MEDICAL EXAMINER – HIGH DESERT FACILITY REPLACEMENT SPECS. NO. 7883; C.P. NO. 87890

NOTICE TO BIDDERS "A"

Model XR5FC Wiring Diagram

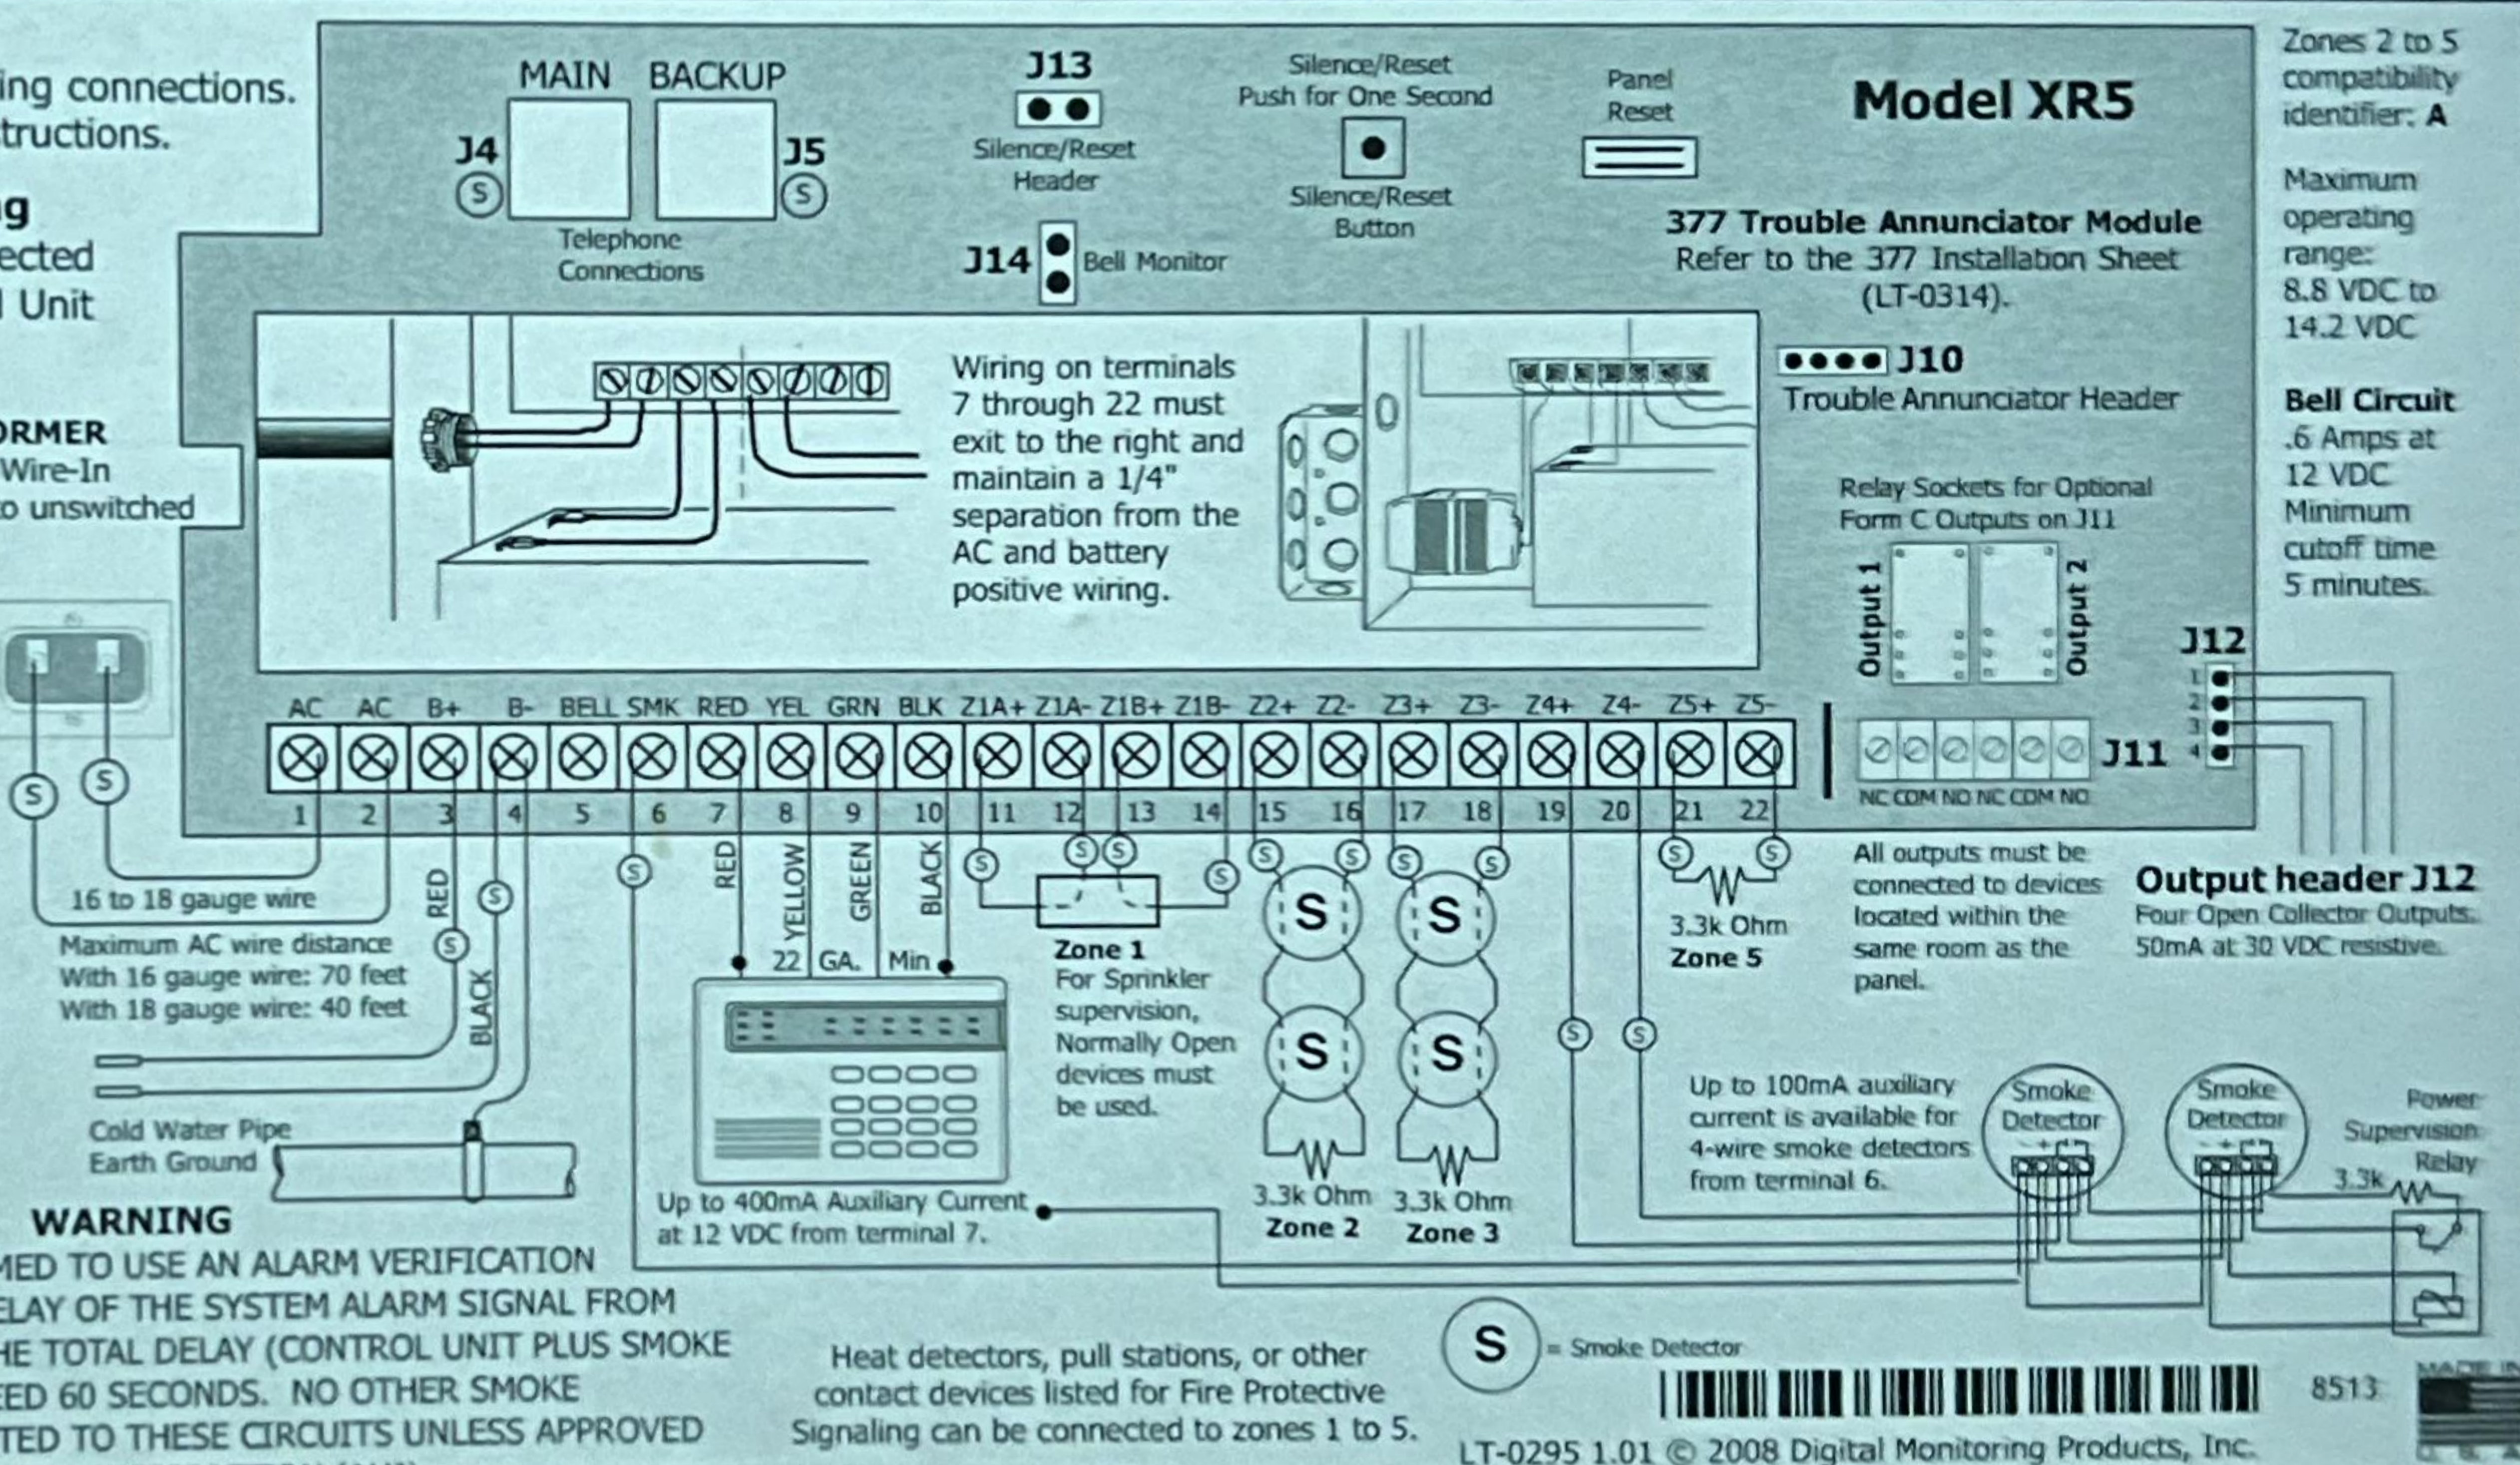
Question 11: What is the brand name of the existing fire alarm system?

Answer: Refer to Sheet E-2.4o, Detail #1 on for the existing fire alarm manufacturer, DMP#XR5FC (Attachment 4).
